***Site 53,
No.2 Figtree
Drive, Sydney
Olympic Park -
Minor Internal
and External
Alterations***

State Significant
Development
Modification Assessment
(SSD 7662 MOD 3)

November 2019

Figure 5 | Approved (left) and proposed (right) apartment configuration on Level 12 of Building 2 (Source: Applicant)

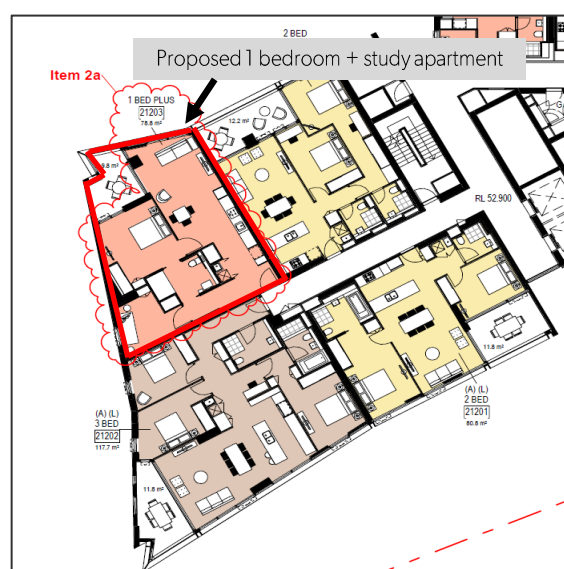
The application is seeking approval to convert 10 x 2 bedroom apartments into 10 x 1 bedroom and study apartments on Level 12 to 21 of Building 2 (**Figure 10**). The Applicant notes the 10 apartments being changed are located in the north-western corner of Building 2. The Applicant notes the proposed modification results in a greater diversity of housing stock as shown in **Table 1**.

The Department notes the internal layout of the 10 apartments is reconfigured to include a larger bedroom, one less bathroom and an increased open plan living space. The Department considers the proposed conversion of the 10 apartments to 1 bedroom and study apartment is acceptable as it provides a wider variety of housing stock for the site. The Department considers the proposed modification is of a minor nature as there is no change to the floor area which remains as 78.8 m². The Department also notes the proposal would not generate any additional traffic movements or parking demand.

The Department has assessed the reconfiguration with regard to SEPP 65 in **Appendix B**. The Department notes SSD 7662 approved 10 x 2 bedroom apartments in this location and concludes the proposed new configuration would maintain an adequate level of amenity for future residents. The Department therefore considers the proposed change to residential apartment types is acceptable.

Figure 6 | Approved (left) and proposed (right) amended roof plant screen on Level 25 of Building 2 (Source: Applicant)

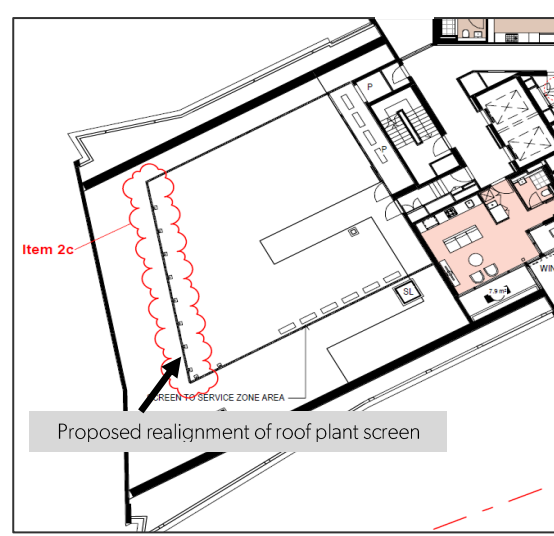
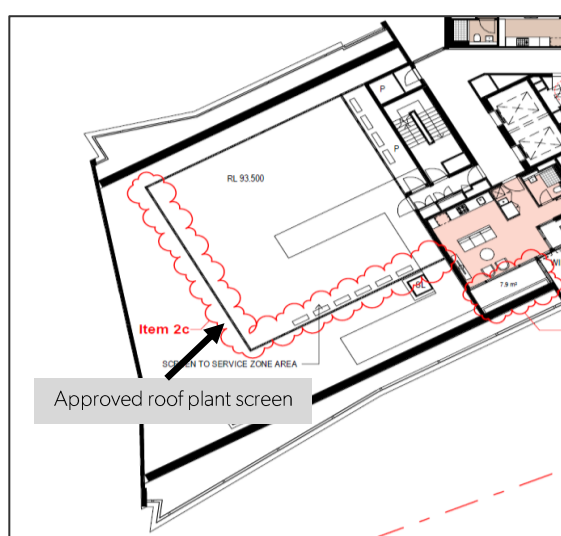
The modification seeks to realign the south-western edge of the plant area and associated screening on Level 25 of Building 2 (**Figure 13**). The Applicant notes the changes are due to the rationalisation of the plant room layout and maintenance access requirements.

The Applicant notes the size of the rooftop plant will slightly increase, however the alignment of the screen ensures the building form and bulk is reduced when viewed from Fig Tree Drive (**Figure 14**). The Applicant submitted updated overshadowing diagrams which demonstrates the changes to the rooftop plant area will not result in an increase in overshadowing.

The Department considers the realignment of the plant area on Level 25 of Building 2 is acceptable as it will have a minor visual impact when viewed from Fig Tree Drive. The Department has reviewed the overshadowing diagrams and is satisfied there will not be an increase in overshadowing at the site. The Department notes that whilst the rooftop plant area is increasing, when viewed from the street level the changes would not result in any adverse visual impacts.

Figure 13 | Proposed increase of roof plant area on Level 25 Building 2 (left) (Item 2c) and reduction to roof plant area on Level 24 of Building 5 (right) (Item 5b) (Source: Applicant)

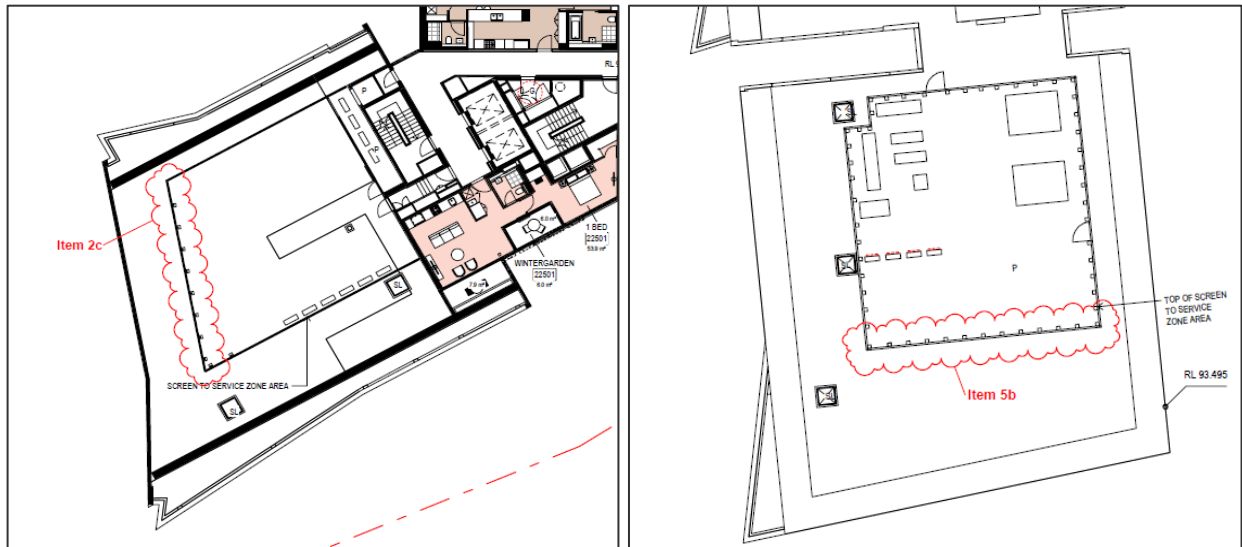
The proposal also seeks to reduce the size of the plant area and associated screening on Level 24 of Building 5 (**Figure 13**). The Applicant notes the modification is required to align the plant area with the approved layout and maintenance access requirements.

The Department considers the amendment to the rooftop plant area on Level 25 of Building 5 is acceptable due to the reduction in size (**Figure 15**). The Department considers the modification to be a design refinement to reflect the approved layout under SSD 7662.
